DEP Contract No. BS028
Task Assignment
Technical Review of the Southeast Florida SAND Study Report Memorandum

Purpose and Objectives

Section 1 - Technical Report Review

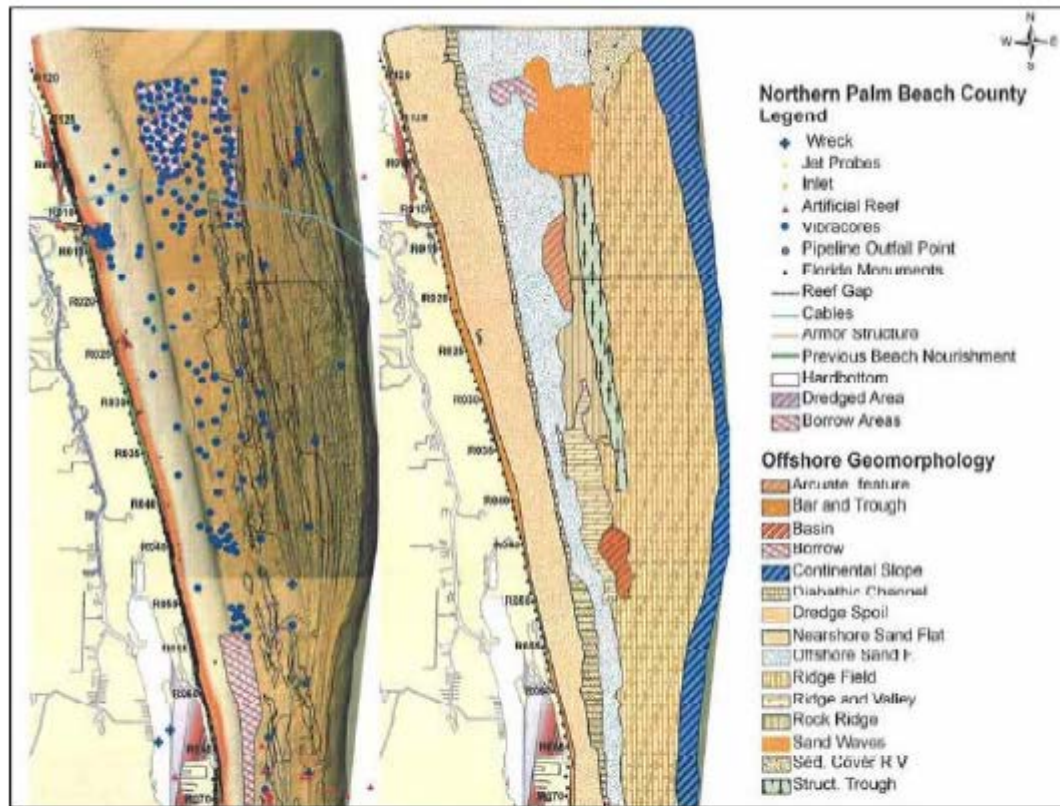
Table 1 is a stratigraphic column for St. Lucie to Palm Beach County. This column is based on a 1971 paper by Meisburger and Duane. Stratigraphic columns are constantly evolving as technology improves and newer information is obtained. It should be possible to locate a more recent stratigraphic column than 1971. The Florida Geologic Survey should have more recent information.

The following are specific comments on the formations shown in the stratigraphic column:

- **Fort Thompson Formation-** Miami and Key Largo limestones and the Anastasia Formation interfinger with the Ft. Thompson Formation.
- **Anastasia Formation-**see comment above.

- **Bermont Formation-** In southeastern Florida the Caloosahatchee Marl is overlain by the Bermont Formation, which is primarily fossiliferous siliciclastics and carbonates.

- **Tamiami Formation-** This formation stretches from the late Miocene into the Pliocene. So it should be shown in the Pliocene. The Tamiami Formation is found on the southwest coast of Florida (Miami-Dade, Collier, Hendry, Lee and Charlotte Counties). Therefore, it shouldn't be included in a stratigraphic column for St. Lucie, Martin and Palm Beach Counties.

- **Hawthorn formation-** This is actually a "Group" not a "Formation." This group includes the Arcadia, Coosawhatchie, Peace River, Statenville and Torreya formations. The Arcadia and Peace River formations are found in central and southern Florida. The others are found in either north Florida or along the west central coast of Florida. Therefore, they should not be included in this stratigraphic column.

- **Oldsmar formation-** This formation consists of micritic limestone and dolomite
- **Cedar Key formation-** This should be the "Cedar Keys" formation.

With the comments above in mind, the simplest solution might be to show a generalized column for south Florida, rather than trying to identify which formations appear in St. Lucie, Martin and Palm Beach Counties.

Response: Citation of the Bermont Formation according to the USGS is actually an informal classification and is inappropriate to incorporate in this report. See: <http://tin.er.usgs.gov/geology/state/fips-unit.php?code=fl2011>. The Miami Limestone is younger than the Fort Thompson and is not interfingered. The citation of Meisburger and Duane (1971) was used because the SAND study replicated the table headings and structure, not specifically the stratigraphy presented within.

To resolve the comment, the stratigraphic column was reduced to units observed no later than the Miocene and captioned to generally represent southeast Florida as oppose to St. Lucie, Martin and Palm Beach Counties. The Hawthorn was left in the stratigraphic section and was annotated as a group as the Hawthorn does exist in the stratigraphy of southeast Florida. The appropriate grading of the Miami Limestone unit with the Anastasia Formation was annotated. Additional references were added.

Screen capture showing the geomorphic units that were identified and mapped on the continental shelf off northern Palm Beach County during the Southeast Atlantic ROSS project (URS, 2007).

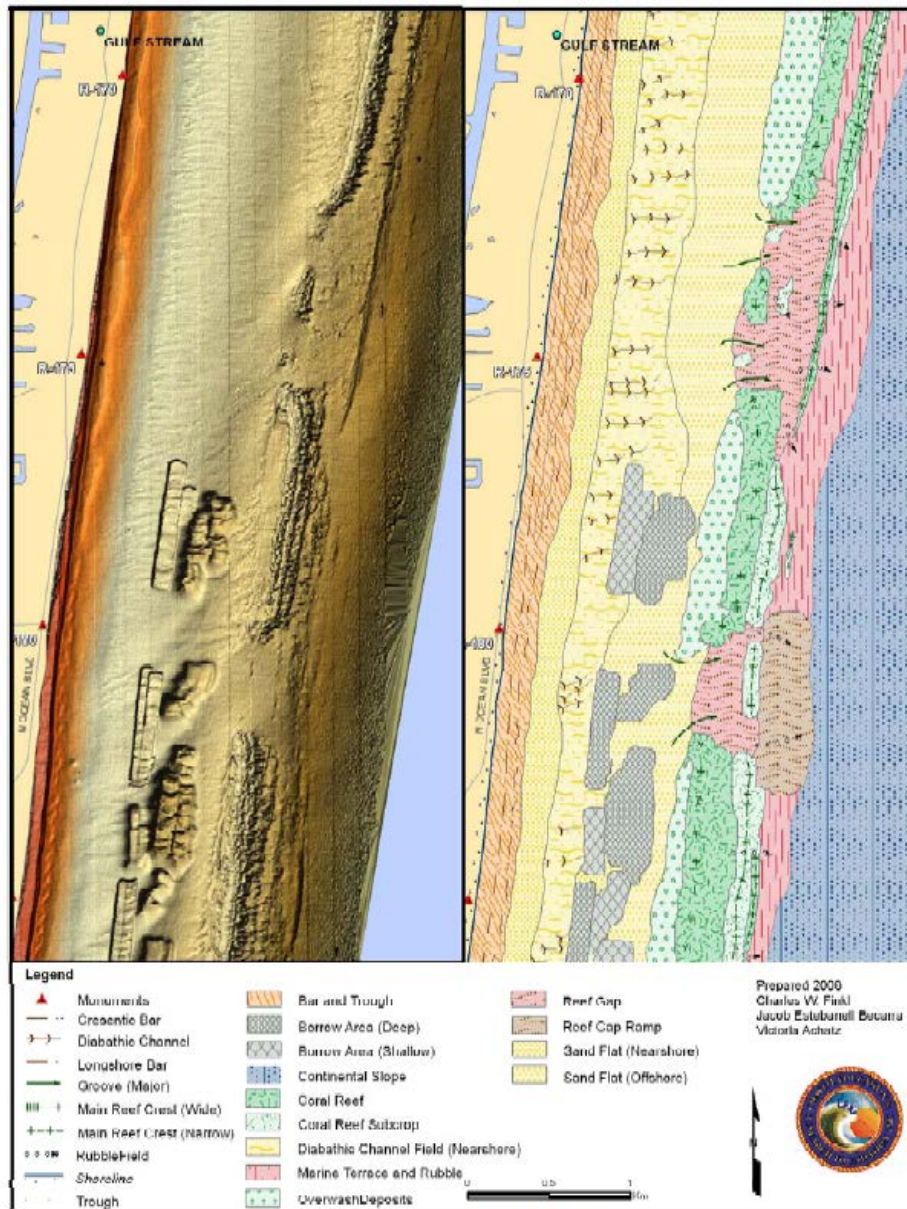
Most of this discussion is based on work that was done in the 1970s. Although the Central Atlantic ROSS report is referenced (URS, 2007), the geomorphology described in the ROSS report is not discussed or incorporated into the analysis. Highly detailed maps were developed for the ROSS project. The overall purpose of the ROSS project was to determine the sand resource potential on the continental shelf along the Florida coast. NOAA bathymetry was used to map seafloor topography, determine geomorphologic units and establish a submarine land topology that could be related to morphosedimentary bodies (see figures below).

These maps have been peer reviewed and published in the Journal of Coastal Research (Finkl et al, 2008). These maps were based on data available through the ROSS database as well as supplemental bathymetric, environmental, cultural resource and infrastructure data. The information should be included in the analysis for the SAND study. A lot of relatively recent work has been conducted within St. Lucie, Martin and Palm Beach Counties (see image below from Finkl et al, 2008). Much of this work provides very detailed descriptions of the local geomorphology. Below is a list of examples of recent studies that have been conducted. The information provided in these recent studies should be included in the discussion of the regional geomorphology.

Because an understanding of the local and regional geomorphology plays such an important role in the identification and delineation of potential sand resources, the discussion provided in this report should be expanded.

Response: Section 1.3.2 is Geomorphology, not Stratigraphy. This section is still a large scale view to understand the context of study area, specifically the upper unconsolidated Holocene sediments. The comments made regarding section 1.3.2 are more applicable to section 2.0 Sediment Distribution. The CP&E review states that the SAND Study was primarily based on work done in the 1970's. However, the text in the SAND Study is actually a review citing sources from 1971, 1997, 2001, 2002, 2007, 2009, and 2011. It includes concepts from the 2007 URS reports noted in CP&E's review, in addition to information provided in the Geology of Florida and several reports produced by the Florida Geological Survey and the US Army Corps of Engineers.

To resolve the comment the SAND Study used 2010 NOAA NOS maps, historical seismic data and 199 additional borings when creating the geomorphology plate. It is believed that the geomorphology depicted in the SAND Study for the areas offshore of St. Lucie and Martin Counties are more accurate than the 2007 URS reports. However, as requested, the maps from the URS 2007 report have been brought in to ensure consistency where pertinent and the SAND study geomorphology map has been

reworked to better correlate to the available seismicity. The reports cited by CPE contain a greater level of geomorphic detail for Palm Beach County and are incorporated into the geomorphology for the SAND Study.

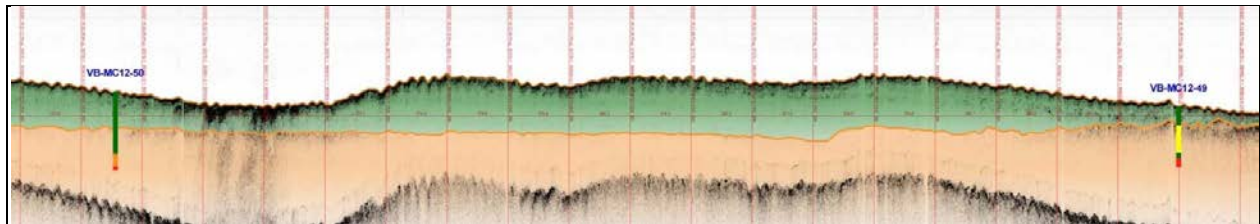
The Borrow Area volume calculation pages from Section 8.0 of the report had several inconsistencies. Historic data for the vibracores and previous design of borrow areas should be provided. The “Number of Cores” reported versus the actual number used for the volume calculations did not match in many cases. Vibracore spacing was variable. The Borrow Area boundaries were not delineated consistently based on the vibracores or geomorphology. The Avoidance Areas were not always excluded from the volume calculations, missing buffers, or located less than one hundred feet away from the borrow area edges and need larger buffers. The reference maps included for the borrow areas were unclear and missing data to correctly interpret the maps. There were also inconsistencies in some of the “Area” calculations.

Response: Sediment source data sheets have been revised; maps improved, numbers made consistent and more thorough narratives have been added.

Summary of Environmental Concerns.

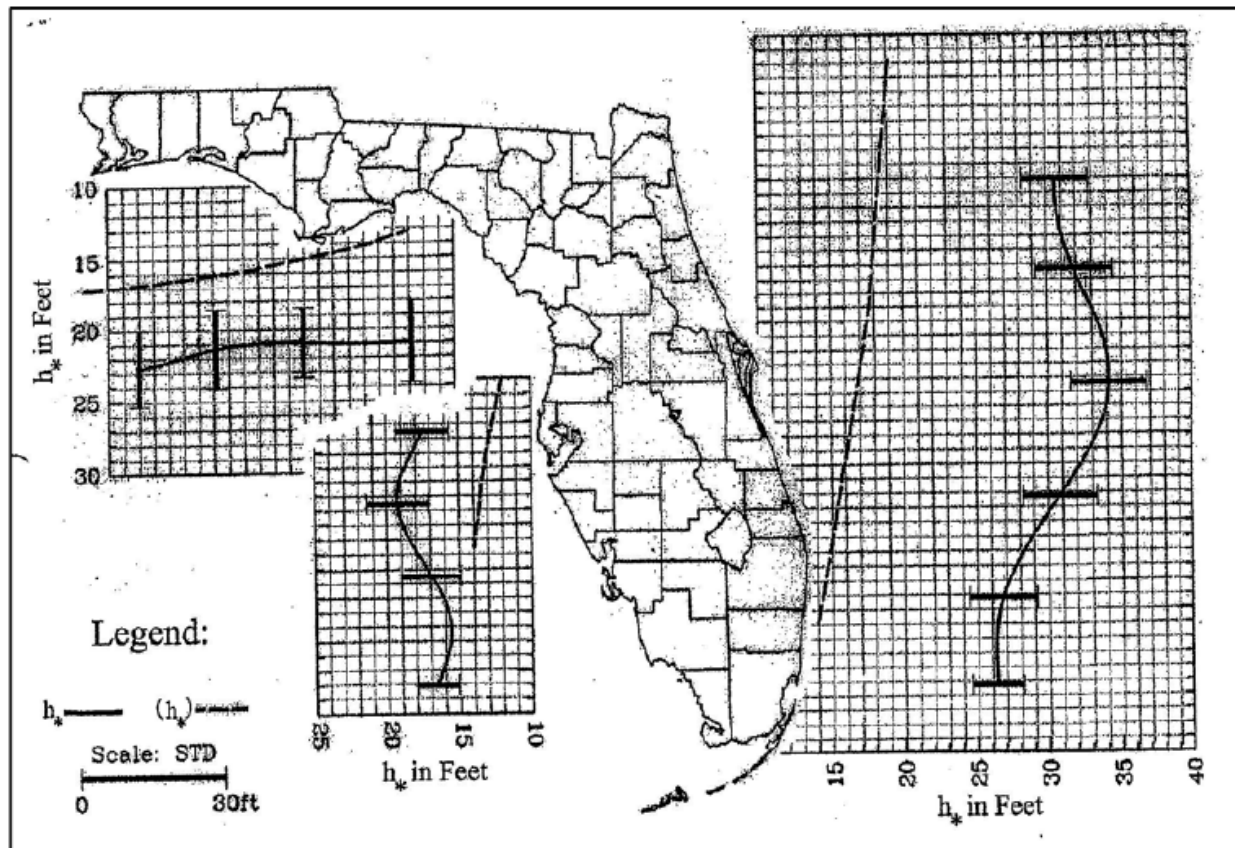
County	Borrow Area	Environmental Offset Issue
St. Lucie	SL1-R23	150 ft. east of the Ft. Pierce Fish Haven (artificial reef)
	SL4-R100A	Hardbottom/cultural resource avoidance area within the borrow area
	SL7-R104	Hardbottom/cultural resource avoidance area within the borrow area
	SL3-R107	Hardbottom/cultural resource avoidance area within the borrow area
	SL1-R32	Hardbottom/cultural resource avoidance area within the borrow area (not excluded from the volume calculations)
Palm Beach	PB3-R8	northeastern most part of the borrow area cuts into the hardbottom
	PB0-R128	100 ft. from nearest hardbottom
	PB0-212	64 ft. from nearest hardbottom
	PB0-223	60 ft. from nearest hardbottom
	PB1-R21	100 ft. from nearest hardbottom
	PB0-R49	100 ft. from nearest hardbottom
	PB0-T215	90 ft. from nearest hardbottom
	PB0-R94	150 ft. from nearest hardbottom
	PB0-R97	50 ft. from nearest hardbottom
	PB0-R201	Patch of hardbottom within the borrow area

Response: The SAND team determined that a 400' buffer was preferred for the SAND Study. Therefore 400' buffers were applied resulting in approximately 30 mc reduction in sediment volume.

Sample vibracore photograph that meets FDEP standards.

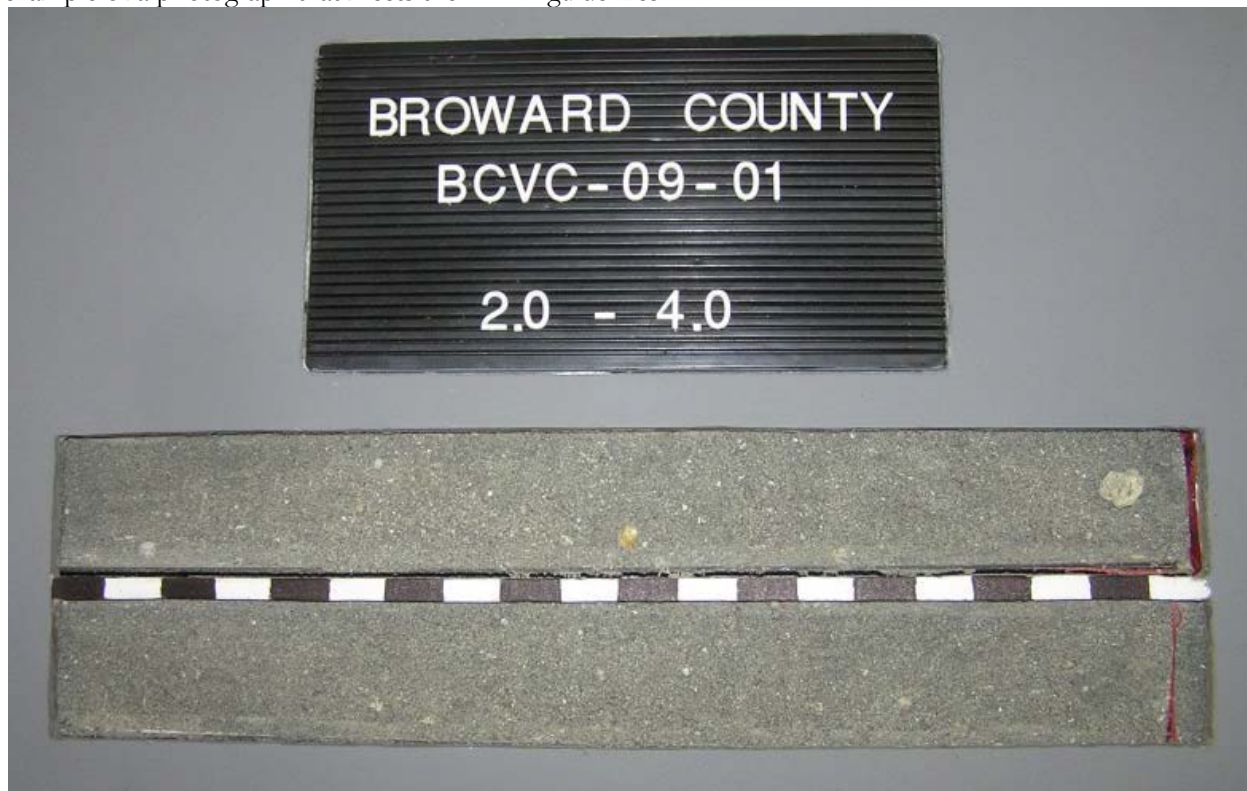
According to the DEP’s sand search guidelines document ([reference: FDEP, 2010. Offshore Sand Search Guidelines. Tallahassee, Florida: Bureau of Beaches and Coastal Systems, 29p.](#)), vibracore photographs should be taken with an 18% gray background. It doesn’t appear that this was done. The image below is an example of a photograph that meets the FDEP guidelines.
